Cubeth EPS design review

June 19, 2014

The goal of this project originally was to test the Electrical Power Subsystem (EPS) board, however due to the numerous errors found in the schematics and the mounting mistakes, the project has been reoriented towards debugging the card from all these flaws. The problems that appeared will be presented followed by their solution. In this project the PCB that has been used is the one that has been manufactured according to Quentin Cabrol's report [1] and diagrams.

Figure 2: OPAs that were mounted backwards

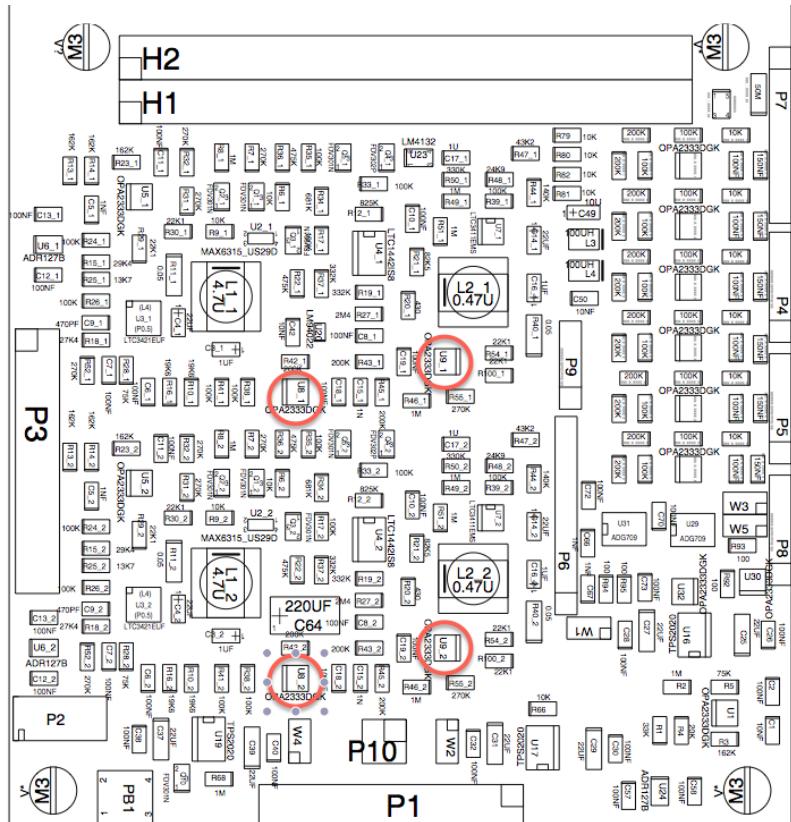
Problem symptoms : When a voltage is applied between the VCC and the GND, the power source gets stuck at 0.7 V and the current rises up the limit imposed by the user on the current limitator.

Source of the problem : The OPAs 2333 U8 and U9 (so it concerns 4 components because of redundancy) had been soldered backwards,i.e the pin 1 was soldered on pad 8 and vice-versa.

Fix: Unsolder them and resolder them in the correct orientation.

Proposition: Serigraph the positions of the pins "1" for active components for future prototypes in order to avoid loosing time due to mounting problems, that are not easy to detect

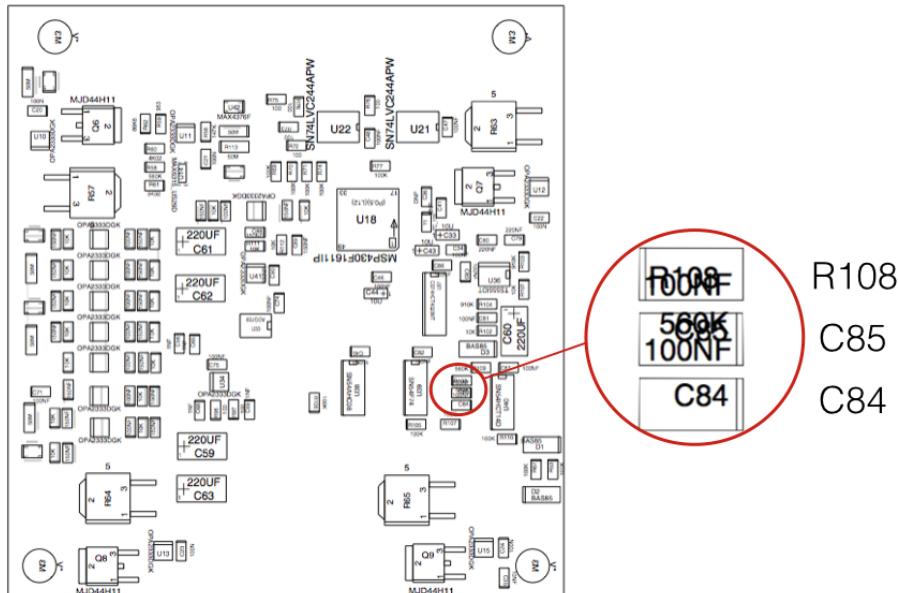
Problem symptoms: None because problem was detected before trying discharge. According to the datasheet a wrong inductor could affect the discharge current.

Source of the problem : $4.7 \mu H$ inductors had been used instead of $0.47 \mu H$. Component is named "L2" on the diagrams.

Fix: Replaced them with correct inductances.

Figure 4: ABF pins

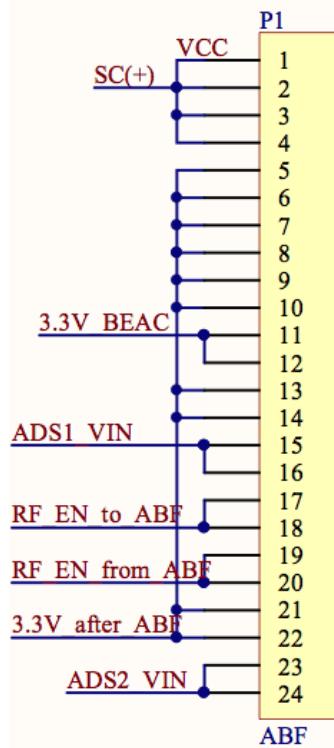
Problem symptoms : VCC is at 0 V even though SC+ was set at 3.3 V through a power source.

Source of the problem : As it can be seen on fig. 4, SC+ and VCC should be connected together through the ABF, however a mistake in Altium Designer was made, and the VCC line was not connected to the SC+ line.

Fix: The plans have been corrected on Altium. A cable connecting the two of them has been soldered on the card.

Figure 5: The output of the ADR 127 B has been mistakenly connected to the ground

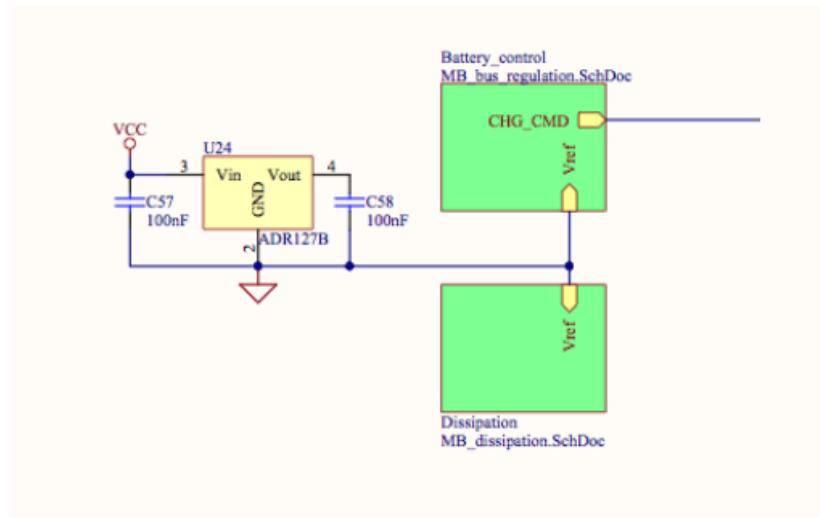
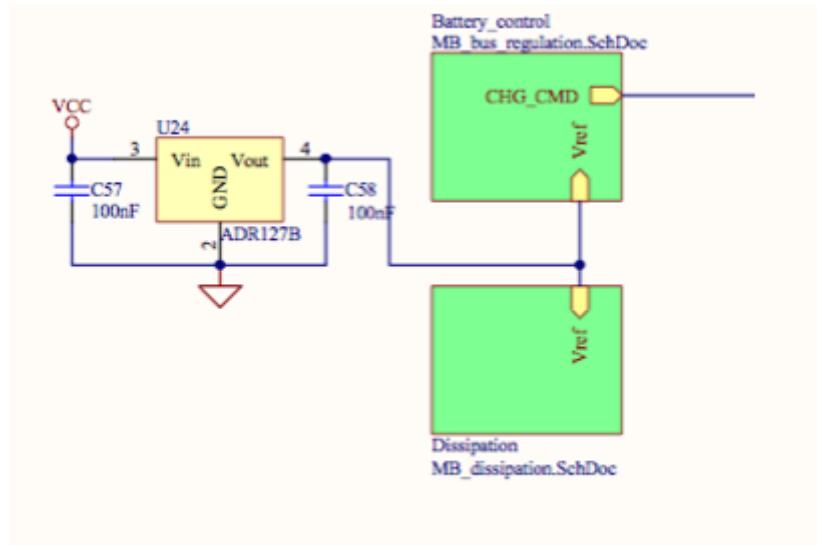
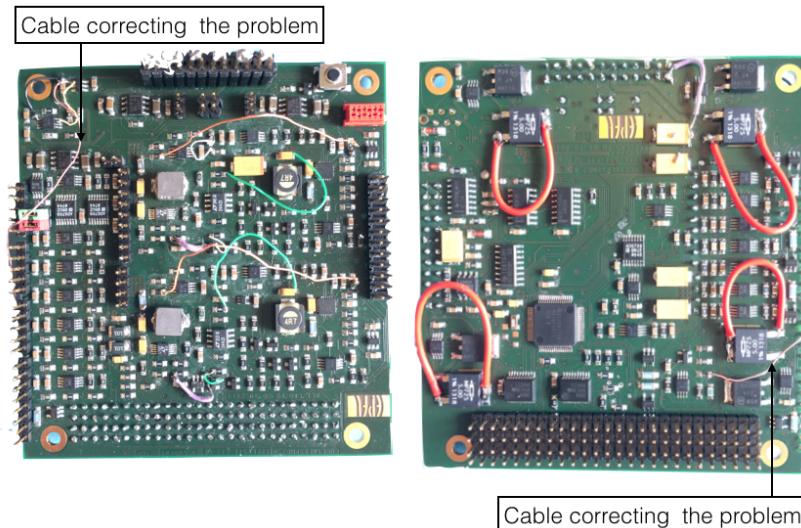
Problem symptoms : The charge command (CHG CMD) was always on a high level and dissipation was always active.

Source of the problem : As it can be seen on fig. 5, the Vref line is connected to the GND, for this reason the comparators in the "Dissipation box" and the "Battery Control" box where comparing the voltage of the bus with the GND, so naturally the charge was always activated as well as the dissipation. Also the routing was made in such a way that R60 was grounded instead of being connected to Vref (U24 pin 4), and the pins 1 an 5 of U1 where at GND instead of being on the Vref line.

Fix: The plans have been on Altium as it can be seen in fig. 6, and the PCB has been corrected physically as seen on fig. 7

Figure 8: The charge diagram with the missing ground

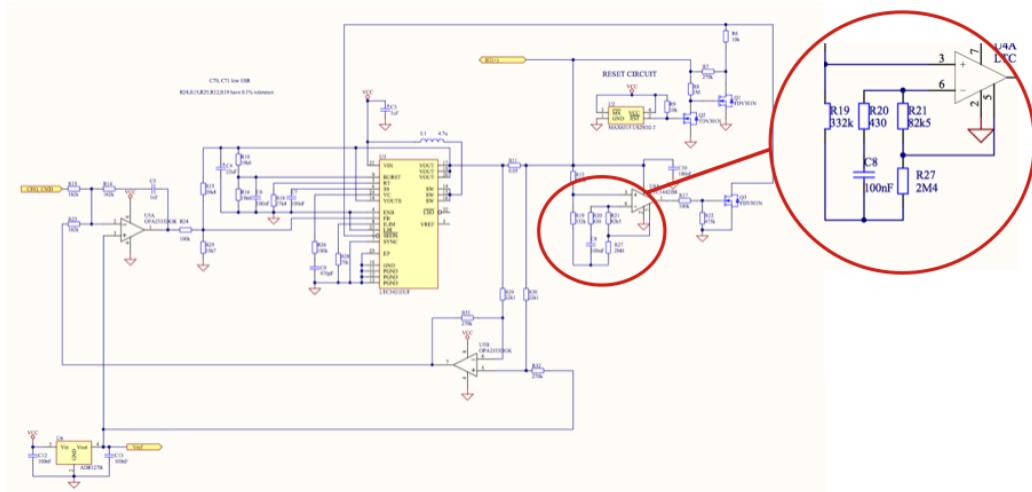
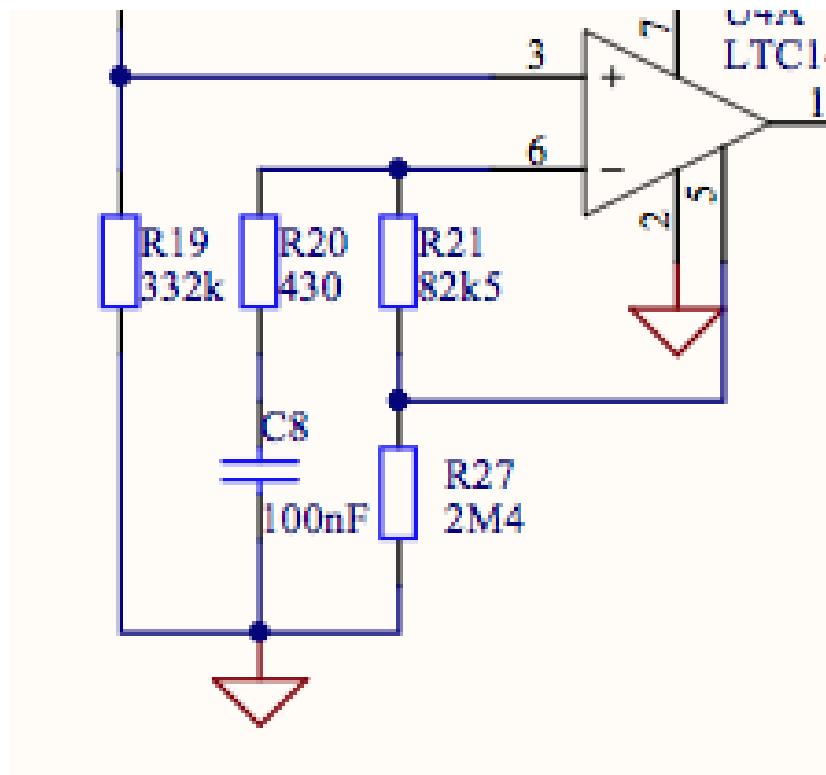
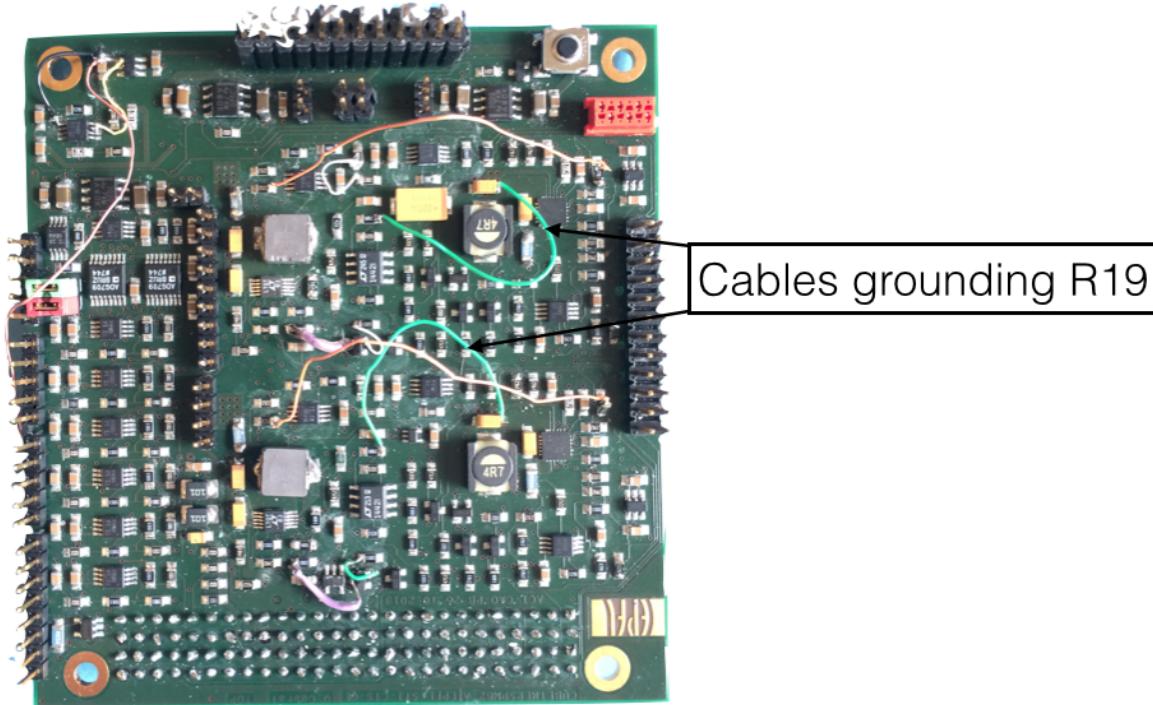
Problem symptoms : The charge was never activated due to the shutdown always activated (active low so level was at 0).

Source of the problem : As seen on fig. 8, at the node of R19,C8 and R27 there should be a ground.

Fix : Added the ground on the diagram and cabled it on the PCB.

Figure 12: On the left the erroneously placed transistor, on the right the corrected diagram

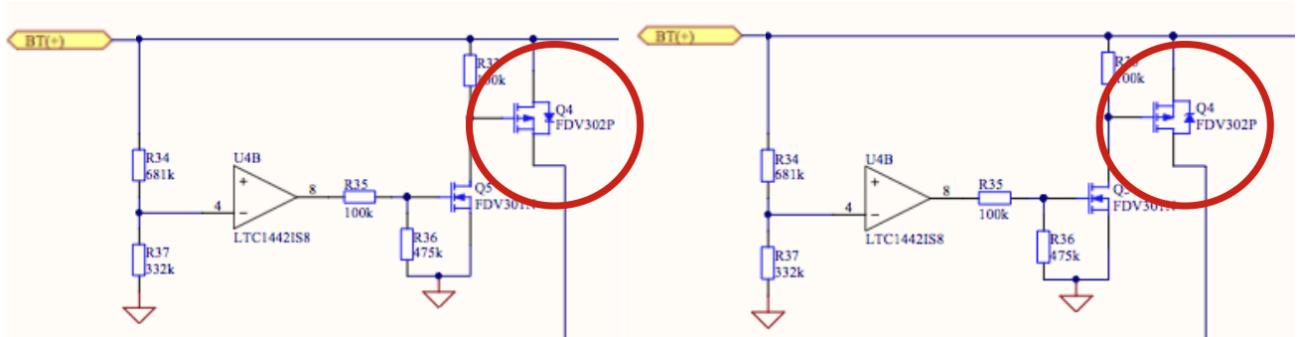
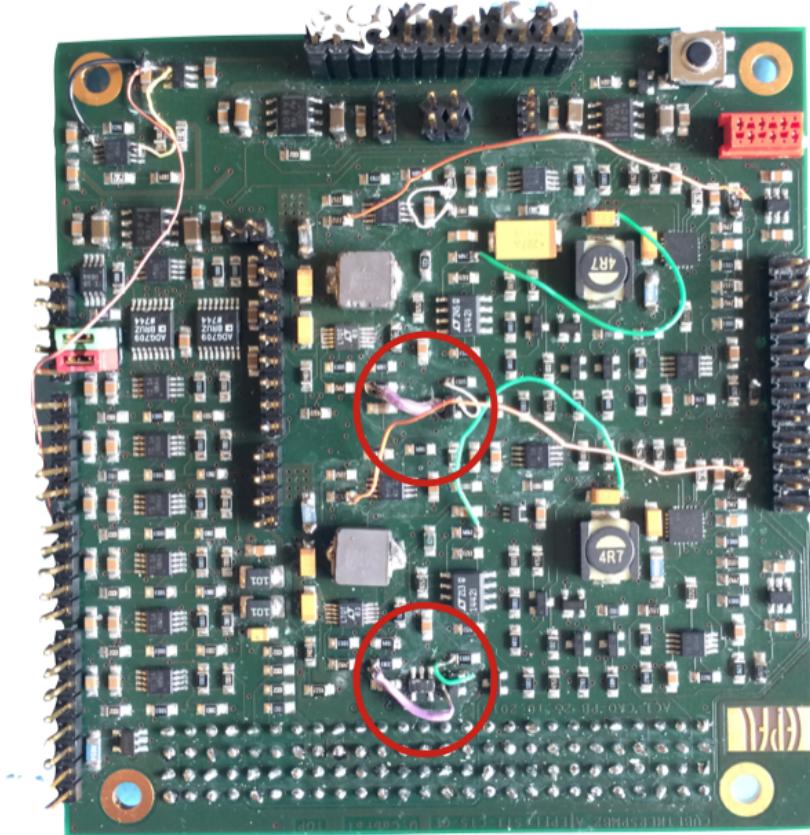
Problem symptoms : The discharge never got activated even when the bus voltage was under 3.3 V and the battery was fully charged.

Source of the problem : In the electrical diagram of the discharge, transistor Q4 had been inverted, the drain was at BT(+) whereas it should have been the source as it can be seen on fig. 12.

Fix : Swisscube diagrams were checked and the transistor has been replaced correctly on the altium plans of Cubeth and a bypass has been made on the PCB.

Figure 15: One of the four dissipation command circuits

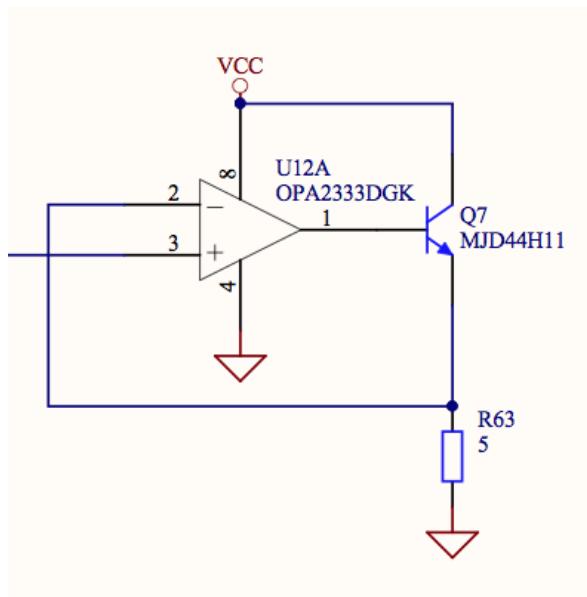
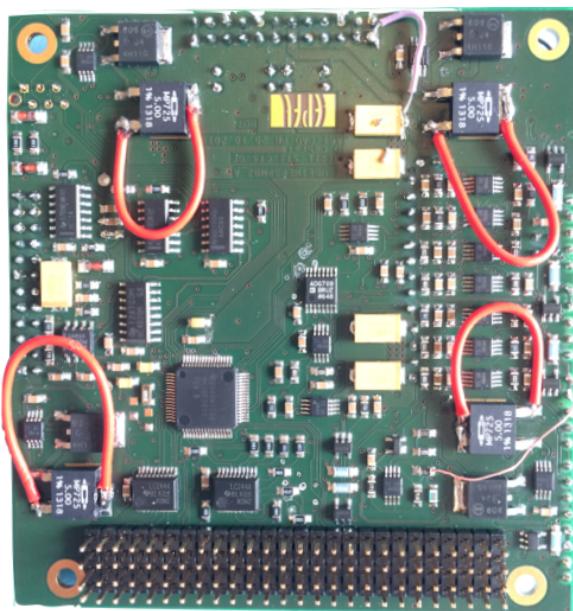
Problem symptoms: Incoherency voltages measured at the pins of the resistors, impossibility to verify if they are dissipating or not.

Source of the problem : Even though the electrical schematics where correct, the routing has been done incorrectly. Pin 2 seen on fig. 14 is the heat sink, it is clearly mentioned in the datasheet that "Resistor element is electrically isolated from the metal heat sink tab". This means that if we look at fig. 15, we should have for example pin 1 on the emitter of Q7 and pin 3 to the ground. However it was found on the PCB that pin 3 hadn't been grounded, only pin 2 (which is grounded for heat dissipation purposes).

Fix: Pin 3 was grounded by adding a cable.

Proposition: Clarify this point with the person that does the routing and check it before PCB is manufactured.

Figure 17: On the left the erroneously placed reference, on the right the corrected diagram

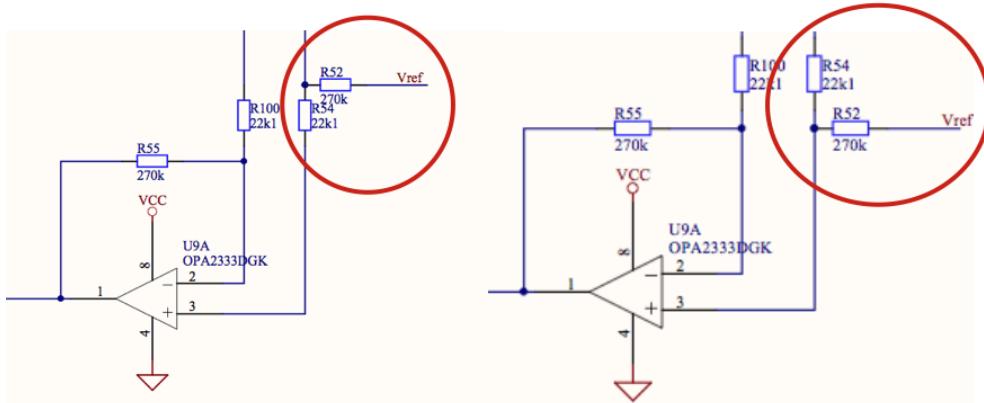
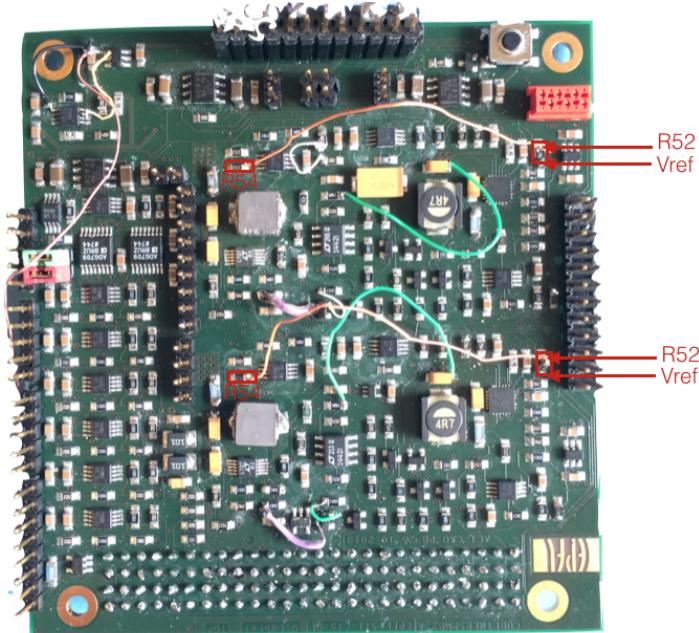
Problem symptoms : Charge and discharge were activated at the same time.

Source of the problem : As we can see on fig. 17 which is taken from the discharge diagram, Vref was arriving over R54.

Fix : Looking at Swisscube's design the diagram has been corrected (Vref arrives under R54), as well as the PCB.
